PRINTWORKS

STUDENT ACCOMMODATION SCHEME

PRINT-1000-ZZ-ZZ-RP-A-0002

DESIGN AND ACCESS STATEMENT ADDENDUM

FIGURE 7. Consented Scheme - Terrace Plan L04

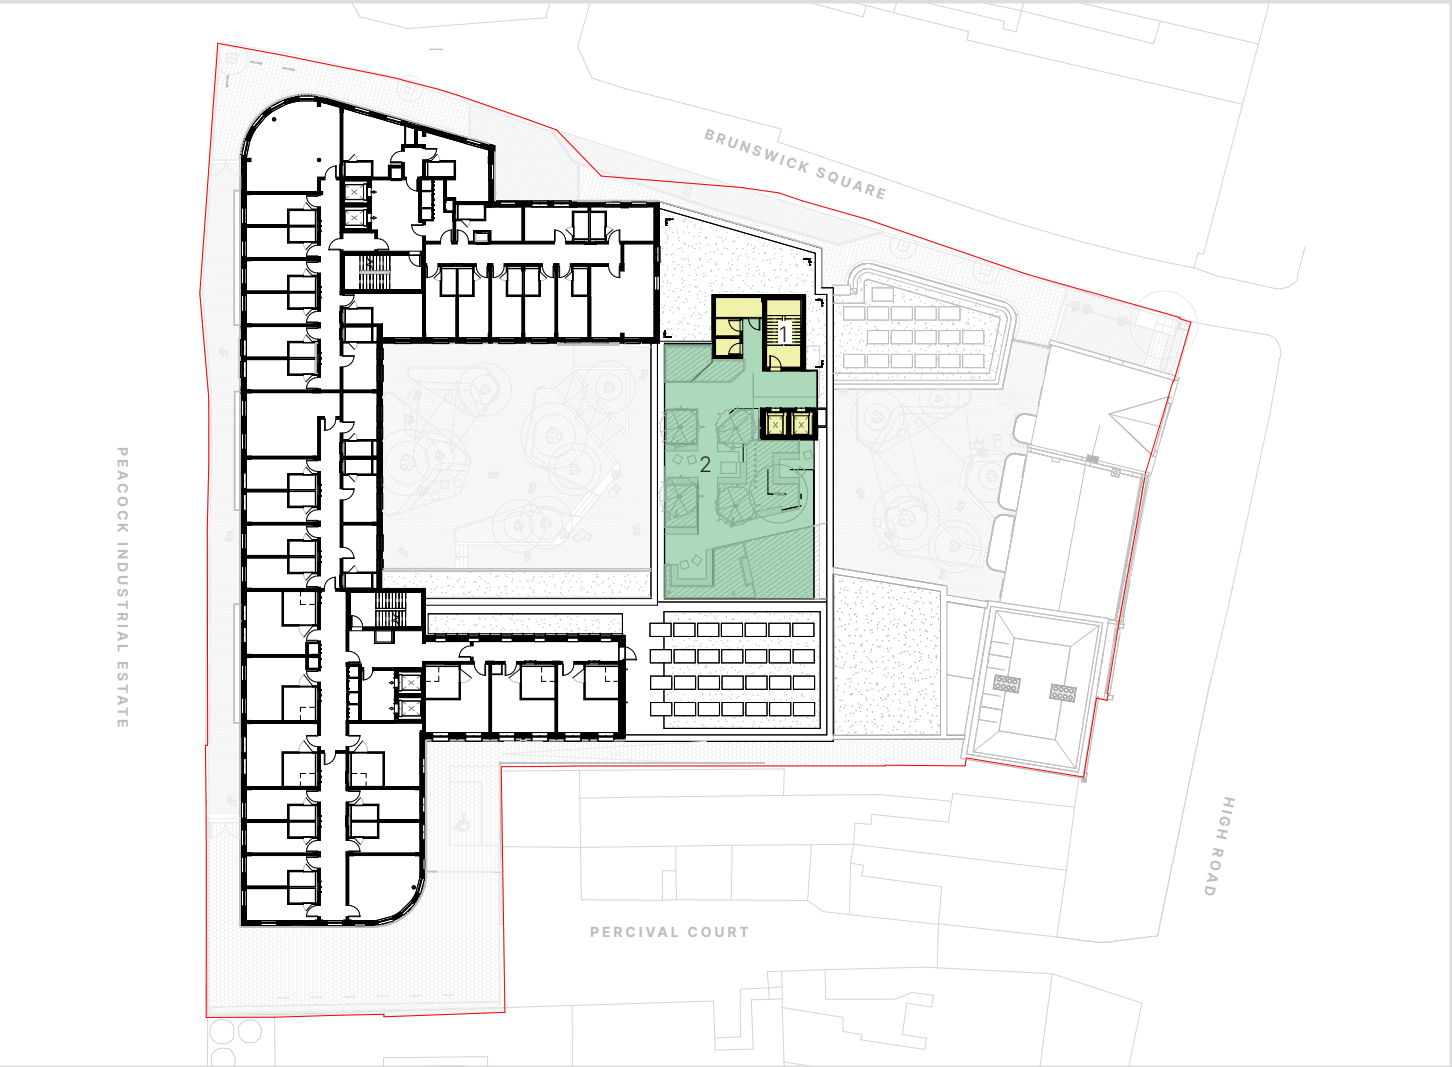
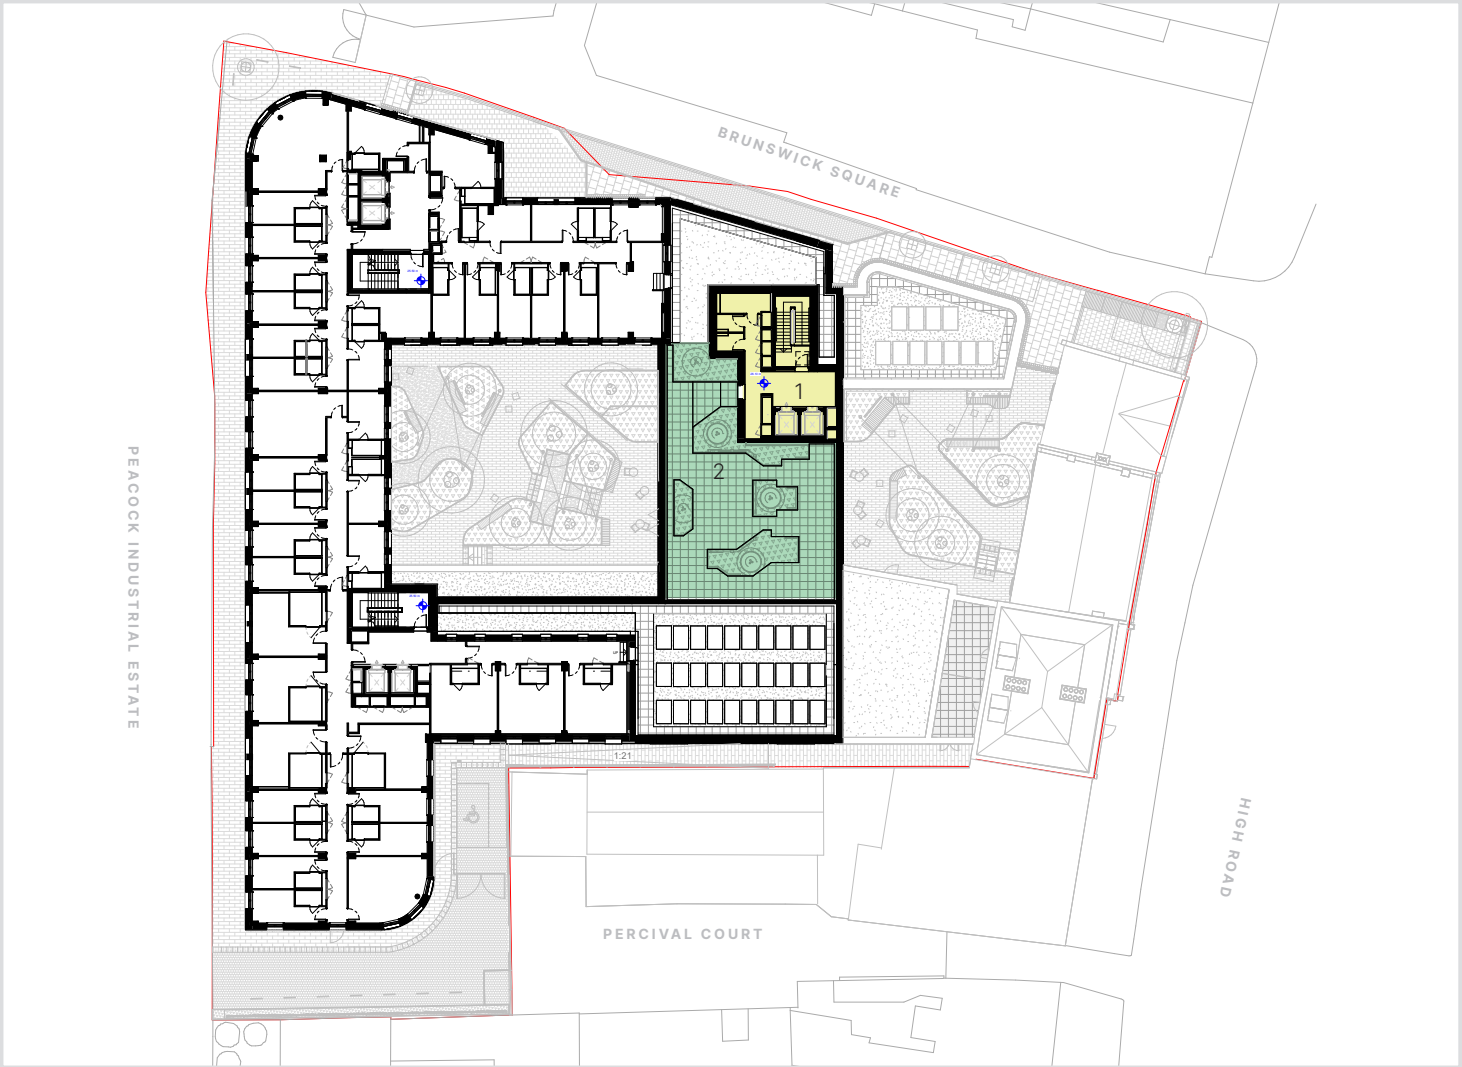
Lobby to core serving 4th floor roof terrace enclosing circulation space.

WCs enlarged to suit ambulant accessibility

Risers added in response to further design co-ordination with fire and MEP engineers.
- 2

Terrace Planter layout revised in response to design development with Secured by Design.
